BMP Inspection Form

Type of Inspection: **1st REINSPECT** FacilityID: **3839205** BMP Identifier: **POND A- EXTENDED DRY**  
Type of Violation: ☒ Notice to Comply ☐ Notice of Violation **DETENTION**  
BMP Score:

# FPL2000-00107 Hamiltons Crossing Fac ID #3839205

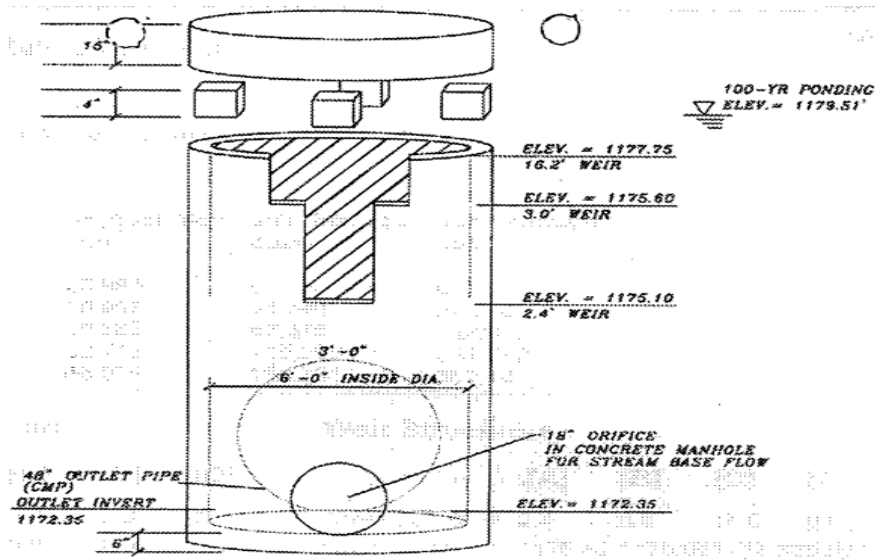
**Repair erosion behind OCS on top of outfall pipe.**
